Access Compliance Report

Public Rights-of-Way

Intersection ID: 10019944	Main Street: ARDREY_KELL_RD	Cross Street: N/A	Location: S
ADA ID: 9C6E20218CE3	Ramp Type: Perp	Initial Pass/Fail: Fail	Overall Compliance: No
		Severity Score: 12.5

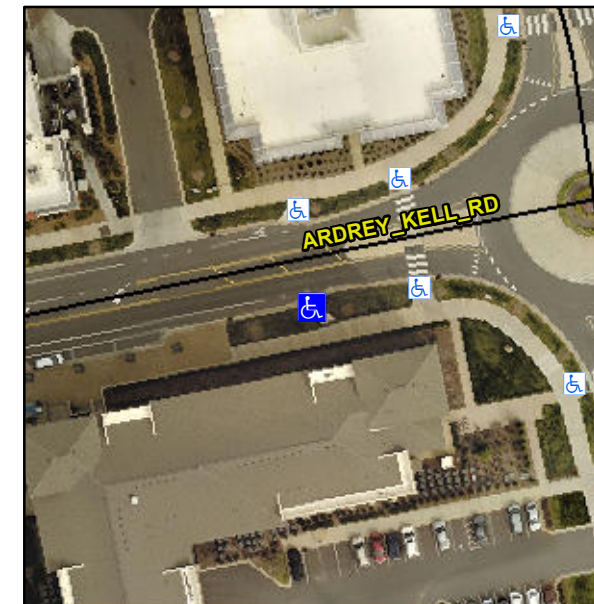
Not Found, R304.2.2

Compliance	Description	Data	Compliance	Description	Data
N/A	Ramp Length (in)	80.0	No	Ramp Slope (%)	8.5
Yes	Ramp Width (in)	60.0	Yes	Ramp XSlope (%)	0.9
N/A	Flare Type LT	N/A	N/A	Flare Type RT	N/A
N/A	Flare Slope LT (%)	N/A	N/A	Flare Slope RT (%)	N/A
N/A	Flare Traversable LT?	N/A	N/A	Flare Traversable RT?	N/A
N/A	Landing Length (in)	N/A	N/A	DWS Provided?	N/A
N/A	Landing Width (in)	N/A	N/A	DWS Contrast?	N/A
N/A	Landing Slope (%)	N/A	N/A	DWS Length (in)	N/A
N/A	Landing X Slope (%)	N/A	N/A	DWS Full Width?	N/A
N/A	Landing Curb? (Y/N)	N/A	N/A	DWS Offset (in)	N/A
N/A	Shared Landing?	N/A			
N/A	Gutter Ponding?	N/A	N/A	Gutter Slope (%)	N/A
N/A	Gutter Lip Ht (in)	N/A	N/A	Gutter X Slope (%)	N/A
N/A	Painted X Walk1?	No	N/A	Painted X Walk2?	N/A
	X Walk 1 Direction	To N		X Walk 2 Direction	N/A
N/A	X Walk 1 Width (in)	N/A	N/A	X Walk 2 Width (in)	N/A
	X Walk 1 Slope (%)	1.5		X Walk 2 Slope (%)	N/A
	X Walk 1 X Slope (%)	0.2		X Walk 2 X Slope (%)	N/A

Remove & Replace Entire Ramp.
